**FW: [EXTERNAL]Communications Travers 5W Walnut****Margaret O. Cooper** <Margaret.Cooper@alexandriava.gov>

Special Use Permit #2020-00108

I would like to address Mr. Travers concerns resulting from the proposed Special Use Permit # 2020-00108 project related to the prospective impact of storm water on his property (5 W. Walnut Street). Indeed his concerns are valid and deserve full attention.

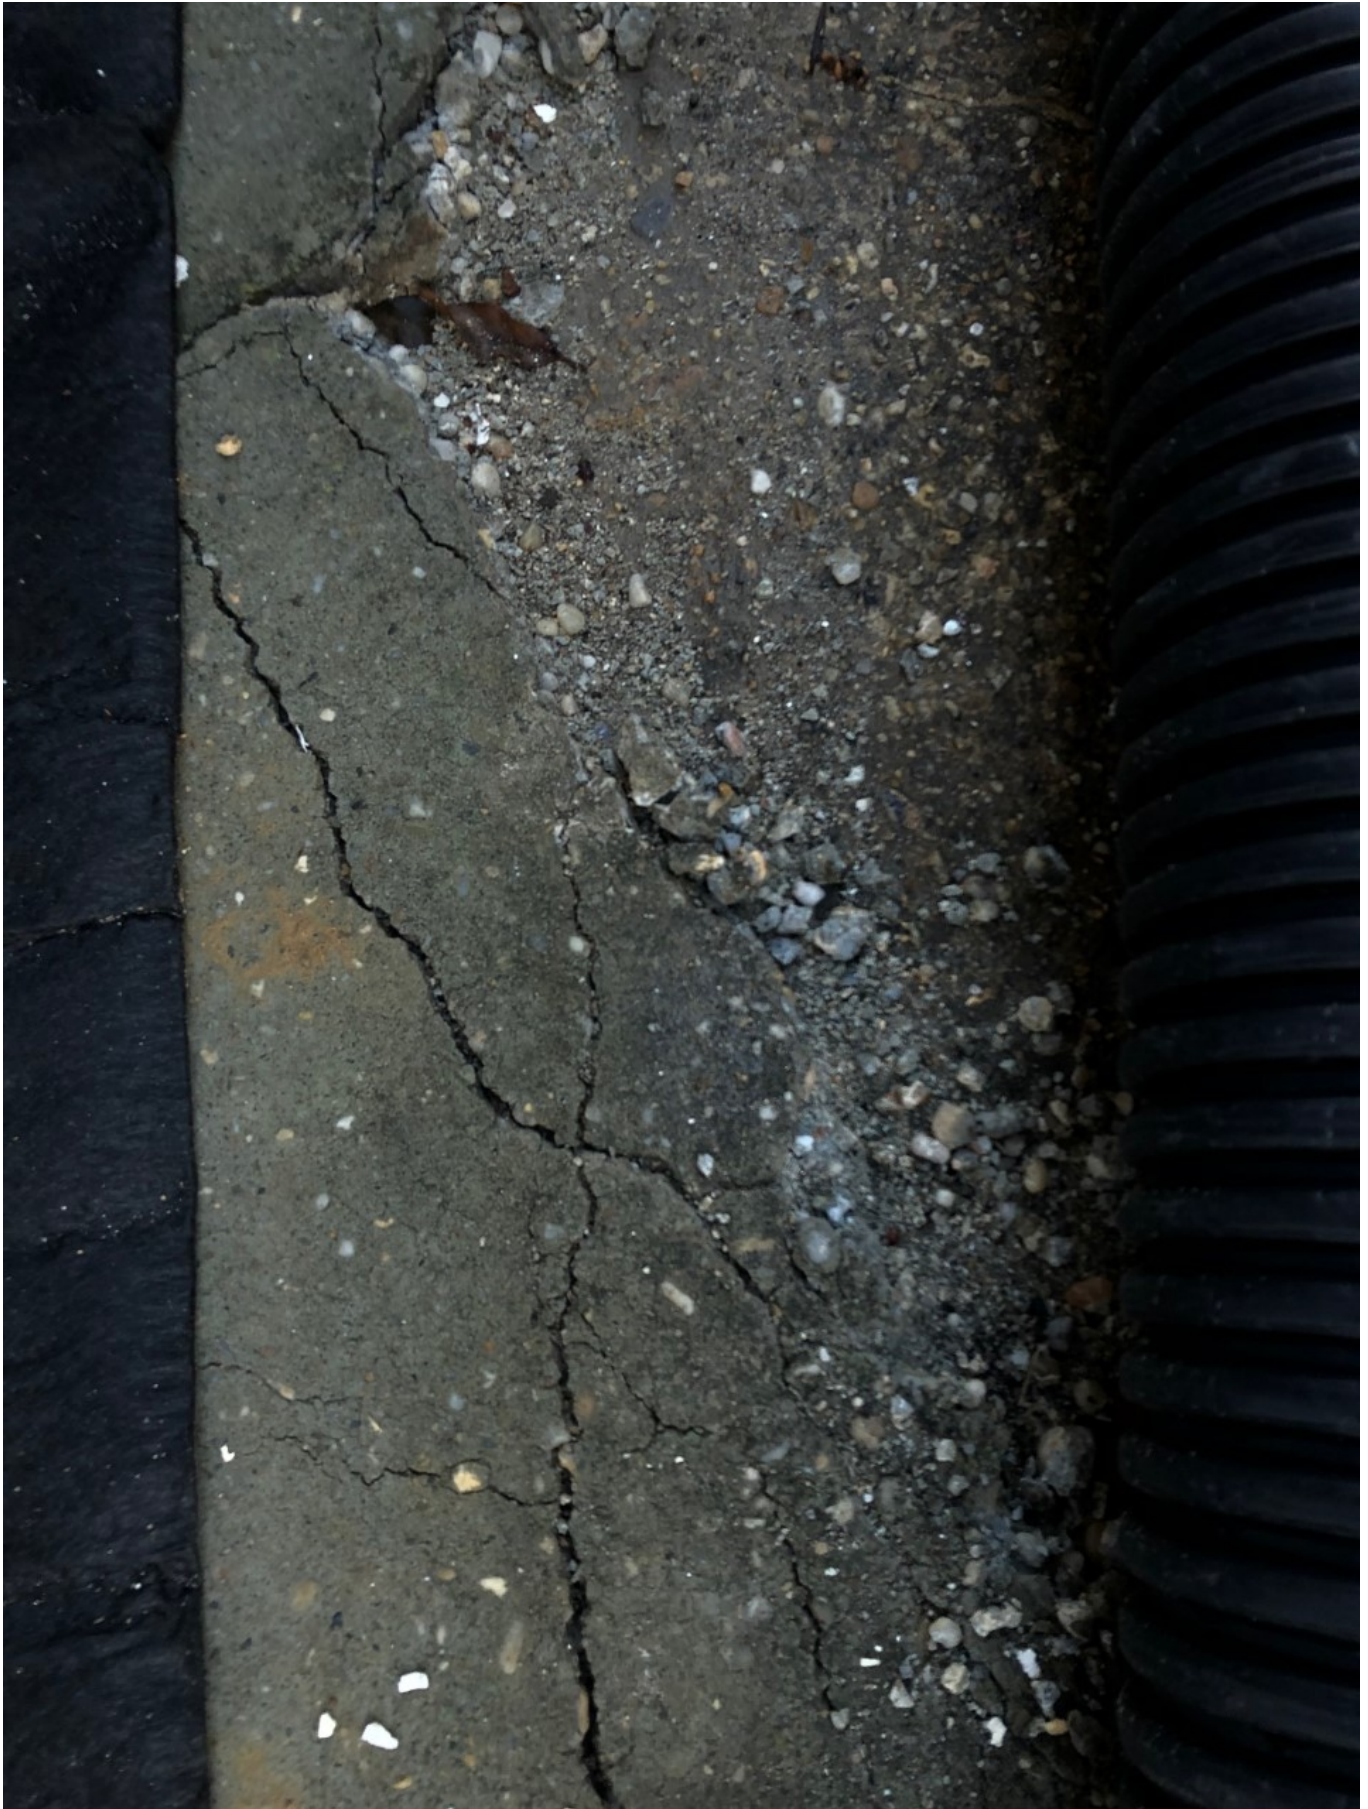
There were some original cracks on the driveway itself as Edgar has provided. The attached photos show the cracks that have happened recently on the cement apron against our house, which are recent.
